## REFERRAL REPORT

TO: Vancouver City Council  
FROM: General Manager of Planning, Urban Design and Sustainability  
SUBJECT: CD-1 Rezoning: 7929-7949 Cambie Street

This report evaluates an application to rezone the site at 7929-7949 Cambie Street from RS-1 (Residential) District to CD-1 (Comprehensive Development) District. The proposal is for a six-storey, strata-titled residential building with a height of 22.3 m (73 ft.), floor area of 2,520 sq. m (27,121 sq. ft.) and floor space ratio (FSR) of 2.6.

**Figure 4: Site Plan**

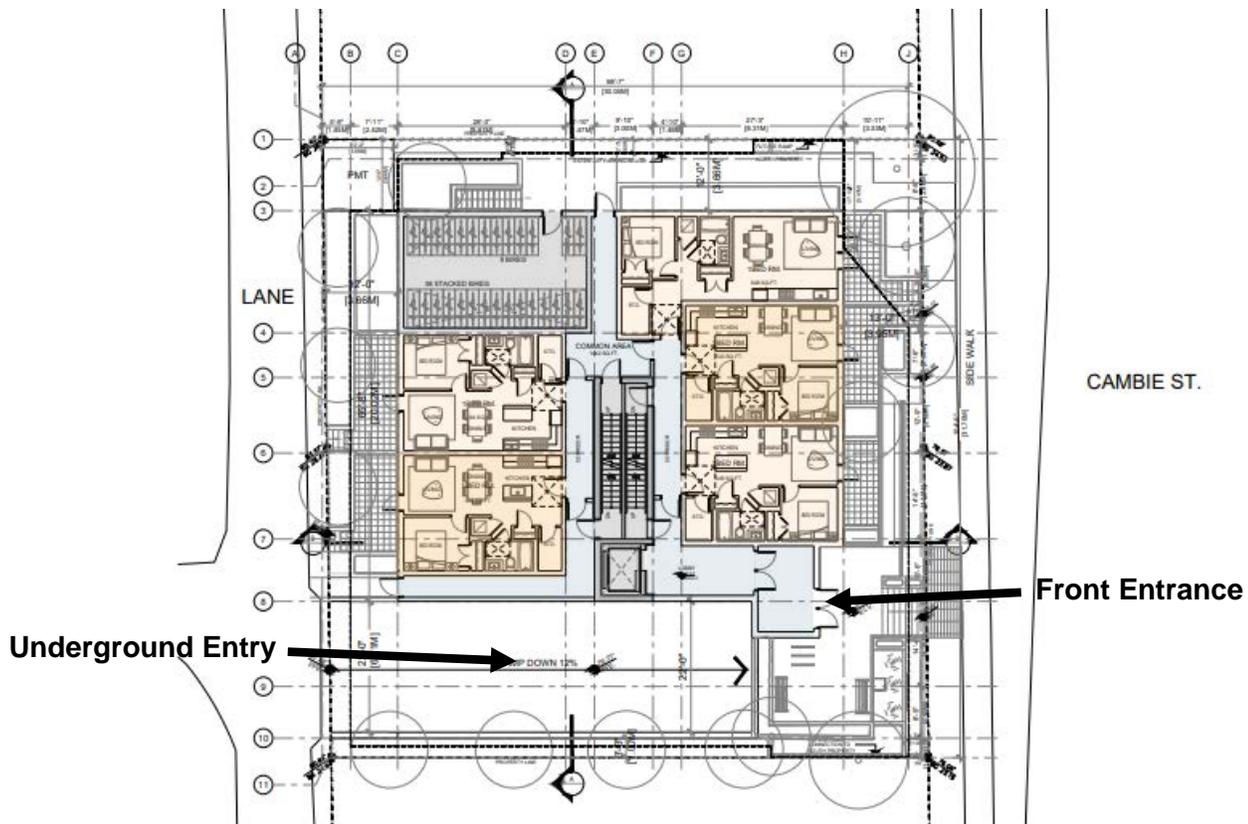
The applicant undertook an analysis of the adjacent single lot to the north at 506 West 63rd Avenue to ensure this lot could achieve its development potential under the *Plan*. Staff determined that the lot could be developed with a six-storey building as envisioned in the *Plan*.
